**From:** Wui, Shawnkaijye <Shawnkaijye.Wui@aig.com>  
**Sent:** Tuesday, 16 October 2018 11:49 AM  
**To:** Shirley Hiew (LKK Auto)  
**Cc:** SUR; Reports (LKKAuto)  
**Subject:** RE: <Re-inspection Report>Your Ref :0110659909SG-003 \*Our Ref: CS/AIG18015078/T1sbe2

### ADJUSTMENT ON REPAIR COST FOR VEHICLE NO. SGA 4493X

Vehicle Reg No.:	SGA4493X	Odometer:	116865km
Make & Model:	Kia Cerato Forte 16SX AT	Colour:	Red
Chassis number:	KNAFW411MA5242742	Date of accident:	01/04/2018
Year of Regn.:	12/10/2010	Date inspected:	16/04/2018
Repairer at:	EM Solution Pte Ltd	Date inspected (After Repair):	20/04/2018
	160 Sin Ming Drive #03-19 Sin Ming Autocity		
	Singapore 575722

PRS photo	Re-inspection Photo
 <p>18/19: 1st Inspection view</p>

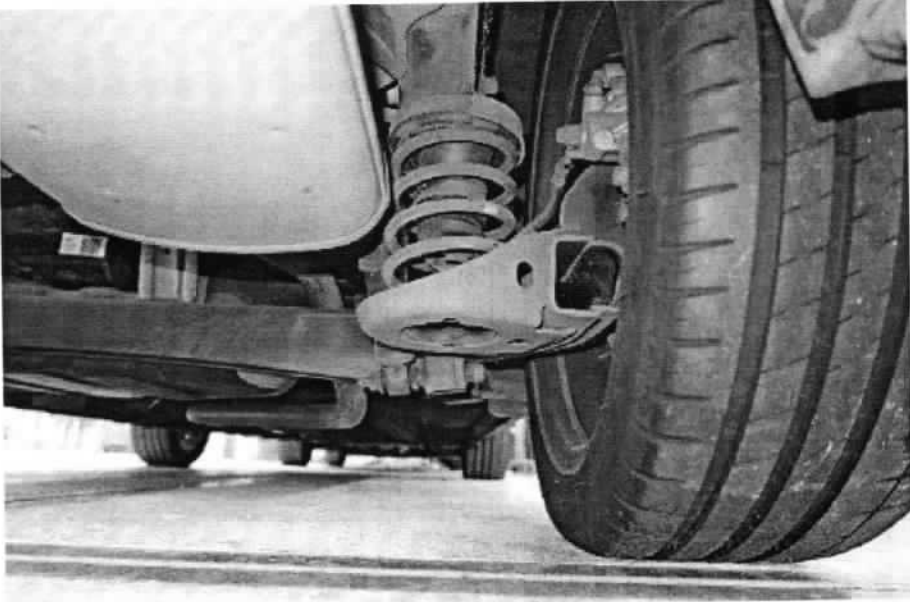
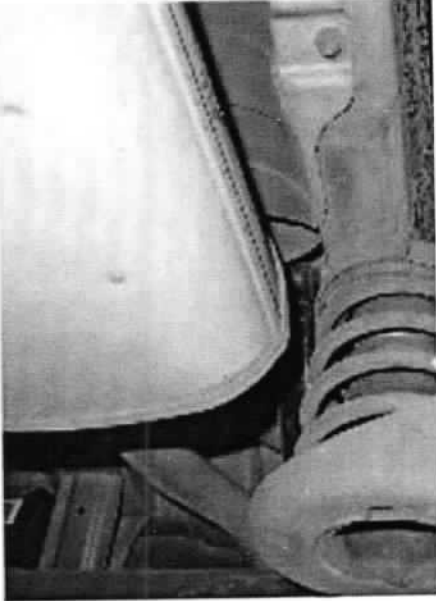
When fender was classified as repaired, it the rear windscreen glass moulding necessary whereby no cutting of fender, no removal of rear windscreen.

For shock absorber RH and rear wheel hub c/w bearing RH, are these two items has been replaced or not necessary?

It seems like there is no replacement.

According to our surveyor, usually when fender is repaired, it is not necessary to remove the rear windscreen, item not allowed for replace.

From the photos, it shows that the damage is minor and its impact is not direct as it's a side swipe case base on the accident report. It is unlikely that the undercarriage will be damage, therefore not necessary to replace, item not allowed.
